Addendum 128 – UN Regulation No. 129

Amendment 10

Supplement 9 to the original version of the Regulation – Date of entry into force: 11 January 2020

Uniform provisions concerning the approval of Enhanced Child Restraint Systems used on board of motor vehicles

Paragraph 4.5., amend to read:

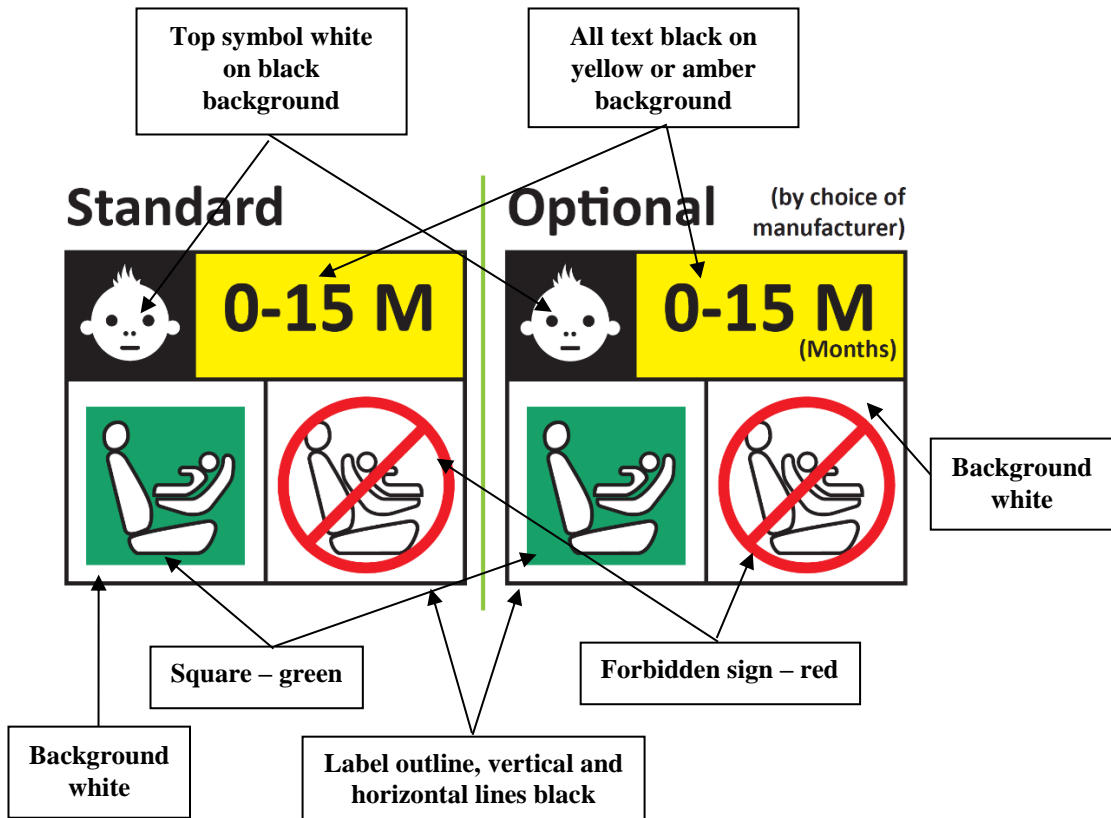
"4.5. Integral Enhanced Child Restraint Systems that can be used forward and rearward facing, shall have the following label permanently attached on the part hosting the child and visible to the person installing an Enhanced Child Restraint System in the vehicle:

The manufacturer shall be permitted to include the word "months" to explain the symbol "M" in the label. The word "months" should be in a language commonly spoken in the country or countries where the product is sold. More than one language is allowed.

Minimum label size 40 x 40 mm

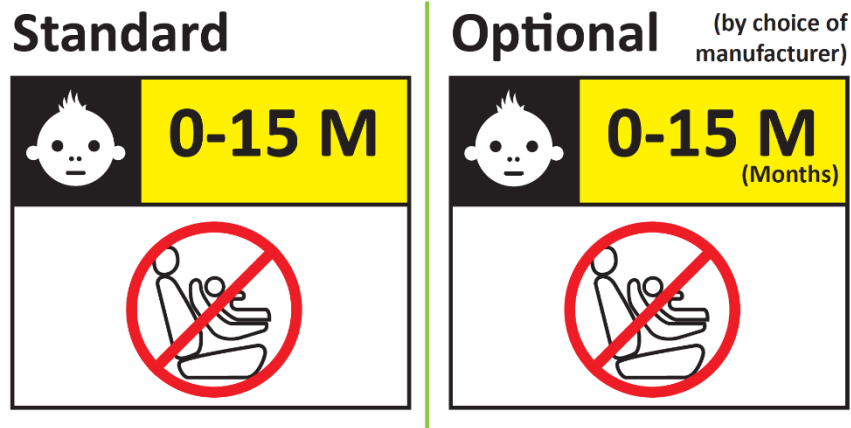
Integral Enhanced Child Restraint Systems that can be used forward facing only shall have the following label permanently attached on the part hosting the child and visible to the person installing an Enhanced Child Restraint System in the vehicle:

The manufacturer shall be permitted to include the word "months" to explain the symbol "M" in the label. The word "months" should be in a language commonly spoken in the country or countries where the product is sold. More than one language is allowed.

Minimum label size 40 x 40 mm
